UCID-20480

TECHNICAL EVALUATION REPORT FOR THE LICENSEE'S  
PROPOSED SOIL-STRUCTURE INTERACTION ANALYSIS  
TECHNIQUES FOR LONG TERM SERVICE SEISMIC  
REEVALUATION: SAN ONOFRE NUCLEAR  
GENERATING STATION UNIT 1

June 1985

FIGURE 2. Horizontal Translation Mode Impedance Spring  $K_{HH}$ , and Damning.

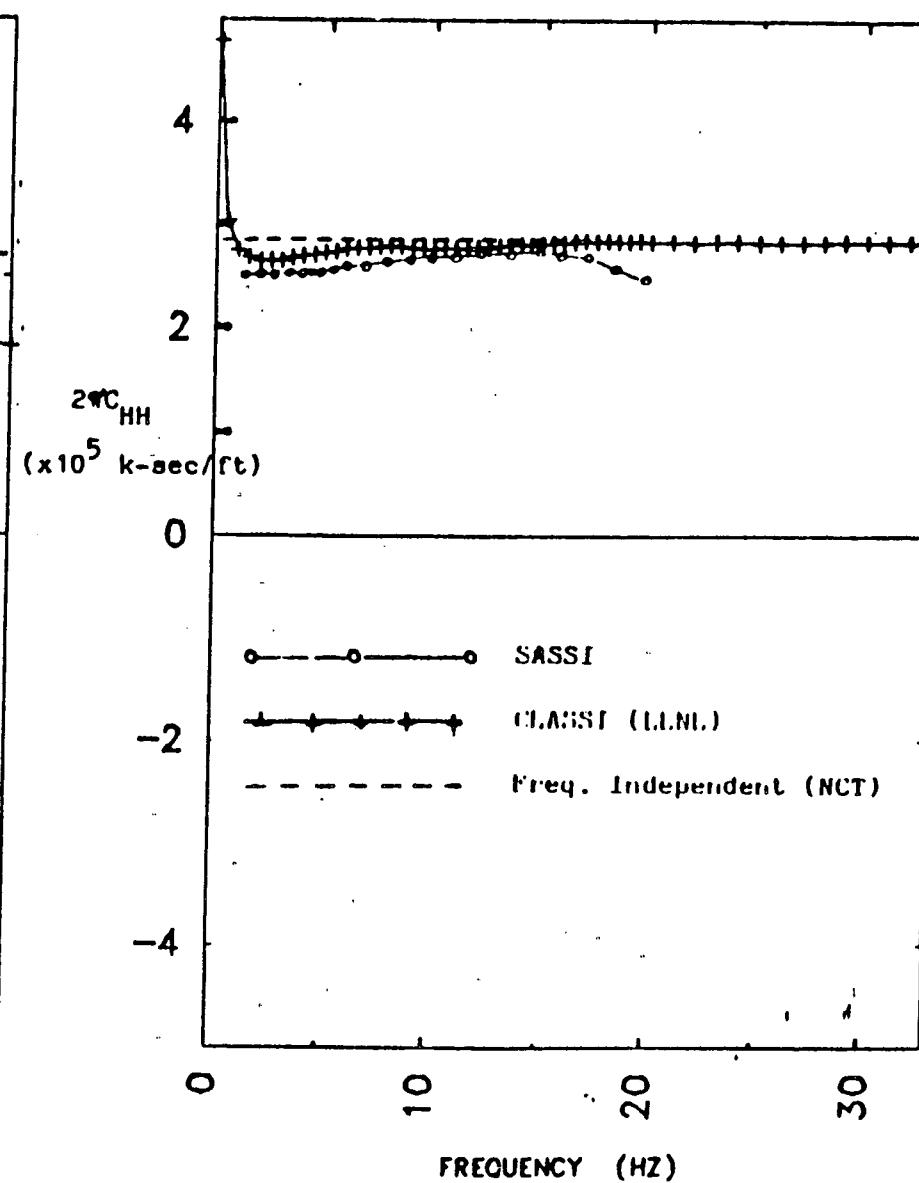
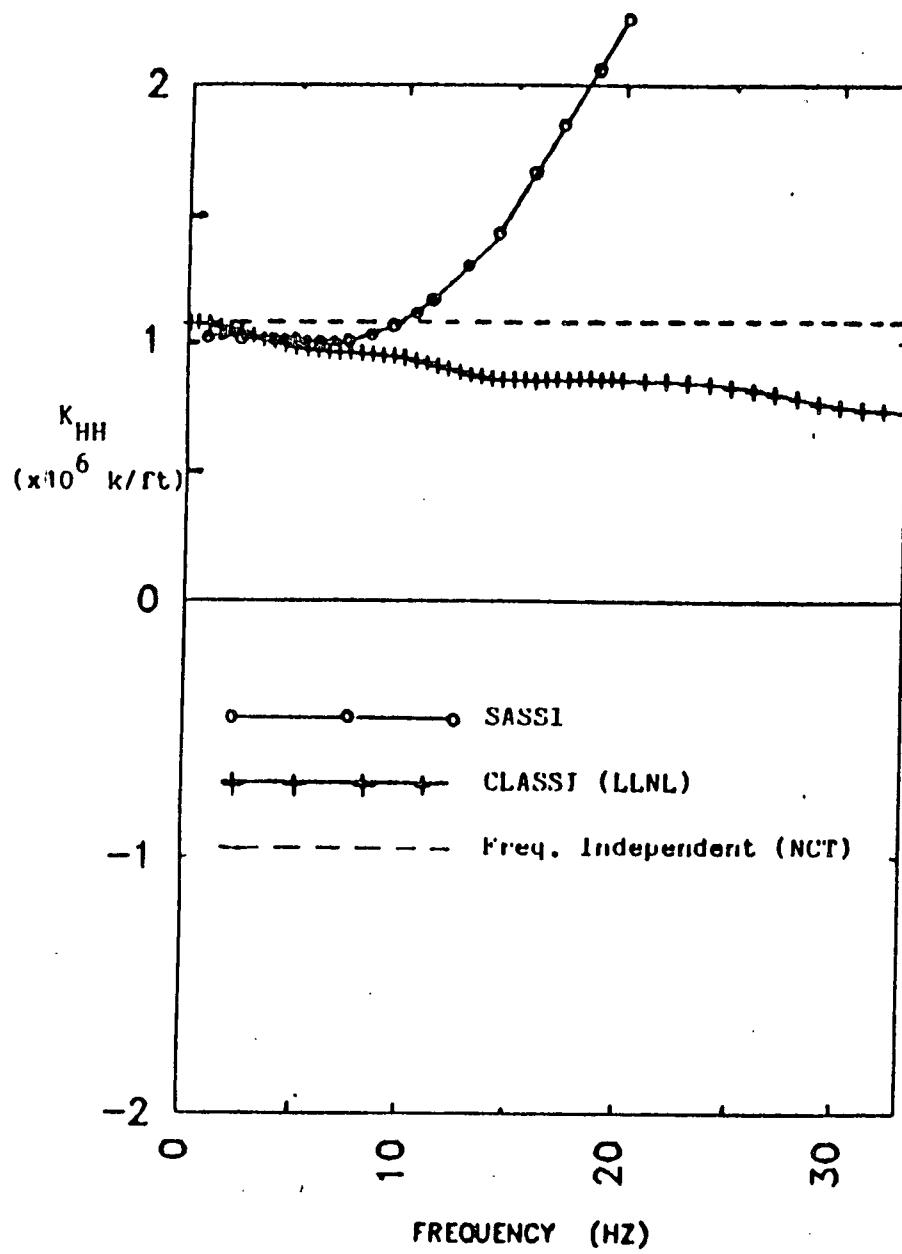
springs (NCT), are compared to each other in Figs. 2 and 3. The subscripts HH and MM stand for the horizontal translation and rocking modes, respectively, of the structural base. The SASSI and CLASSI impedance springs and damping are in close agreement to each other for frequency up to about 7 Hz and 15 Hz, respectively. Beyond these frequencies, the SASSI and CLASSI impedances deviate from each other with increasing frequency. The 2% damping in-structure response spectra at structure nodes 11 (Top), 7, 4, and the base are shown in Figs. 4 to 7, respectively. Twenty-five frequency points were specified for the spectrum generation from all three analyses. The fundamental frequency of the soil structure system is, by inspection, around 2 Hz where the dominant spectrum peak occurs. The licensee solution (Appendix B) is essentially identical to the CLASSI and constant soil-spring solutions at all four locations. The minor discrepancies between the three solutions are anticipated due to the difference in methodology.

In general, we believe the licensee solution is acceptable. The discrepancy in impedances between the SASSI and CLASSI approach does not produce significant deviation in the in-structure response spectrum so long as the finite element mesh used in the SASSI approach is fine enough to produce a sufficient solution for frequencies up to at least the dominant modes of the soil-structure system. The results also suggest that the three methods of analysis, using the same soil and structure properties, can easily produce a different spectrum peak frequencies. Such variation due to analysis methodology should be sufficiently accounted for in the applications to the SONGS 1 LTS program with an appropriate amount of spectrum peak broadening.
